CENTER FOR NUCLEAR WASTE REGULATORY ANALYSES

NONCONFORMANCE REPORT

NCR No. 2003-01

Alloy 22 weld specimens CNWRA Drawing 20-06002-01-081-001 machined by Industrial Mechanical are not within the tolerances. Modifications to the dimensions specified on the drawing were necessary because the Alloy 22 plate supplied to Industrial Mechanical was bowed. Part of the bow was removed by pressing and part was removed by machining the plate surfaces. A detailed description of the non conformance items is provided below:

Alloy 22 Weld Specimen
CNWRA Drawing 20-06002-01-081-001
All Dimensions $\pm 0.005"$
unless otherwise specified
Detail A identified on Page 1

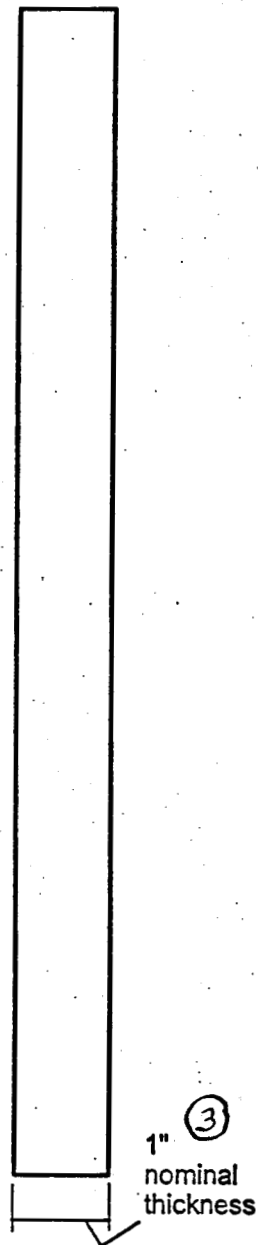
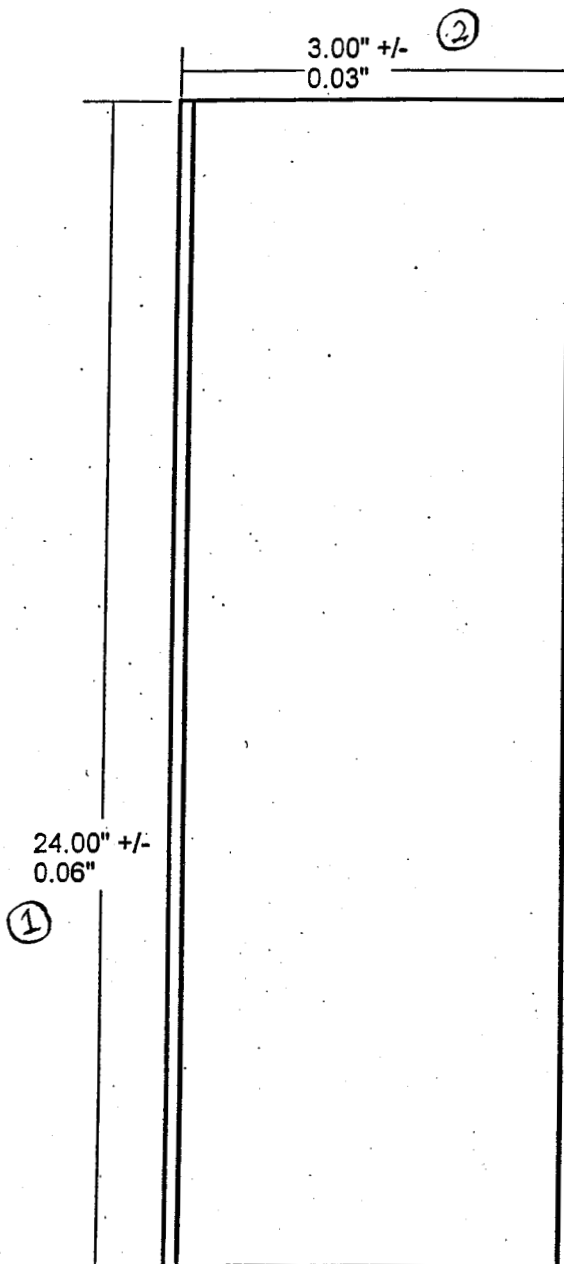
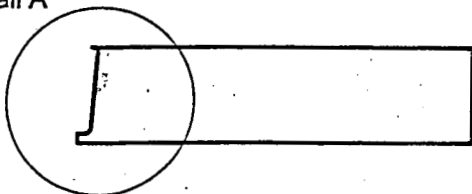
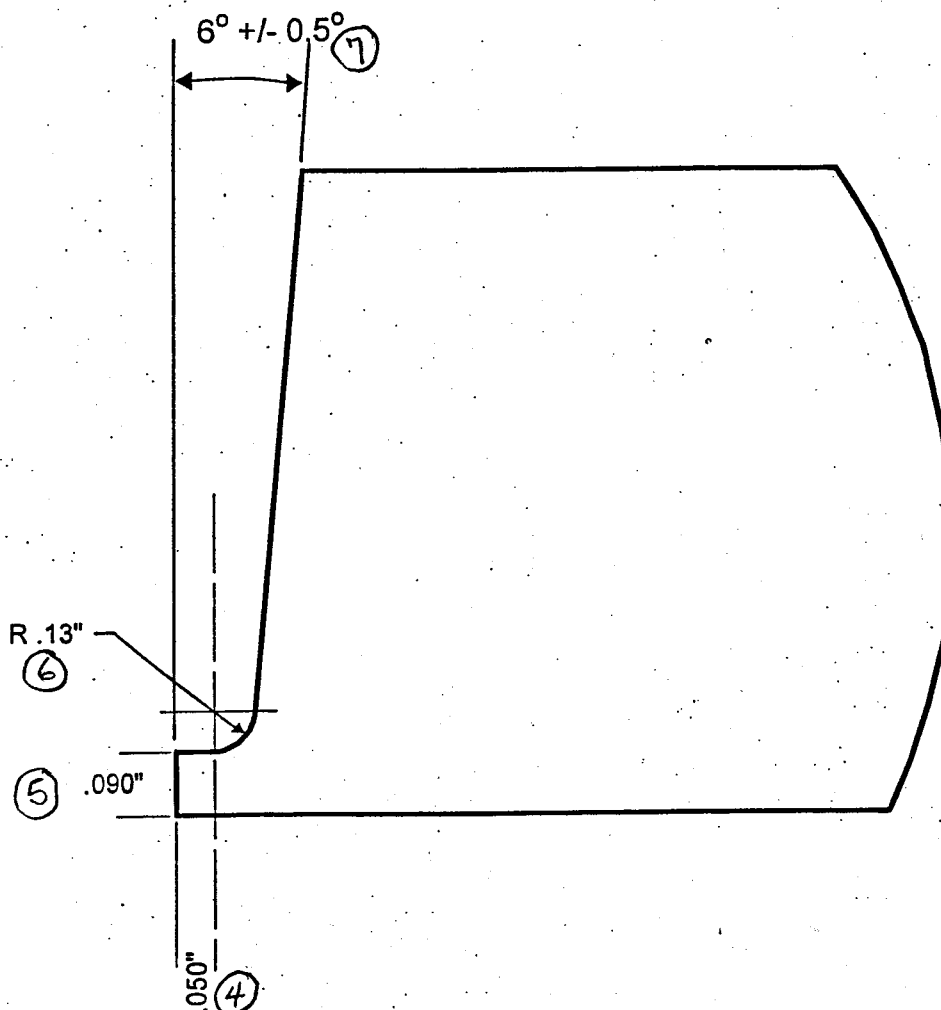
1. Thickness of machined specimens was reduced by 0.005 to 0.030" to remove bow in plate. Final thickness after machining has been provided in documentation provided by Industrial Mechanical. *(all 4 specimens)*
2. Plate C: The 0.090" land thickness measures 0.090 to 0.097"
3. Plate D: The 0.090" land thickness measures 0.093 to 0.100"

Amount of bow in plates prior to straightening: A) .096
(The bow is along the 24" length) B) .060
(Plates are identified A thru D) C) .030
D) .020

Amount machined from bottom face for flatness: A) .005 - .015
B) .010 - .015
C) .030
D) .020

Final thickness after machining: A) 1.020 - 1.025
B) .993 - 1.030
C) .975 - 1.000
D) 1.020 - 1.030

Accept specimens as is.

The variation in the thickness of the land will not affect weldability of the plate. Integrity of the weld joint will be assessed by non destructive examination including penetrant testing of the root pass and radiographic testing of the completed weld. .
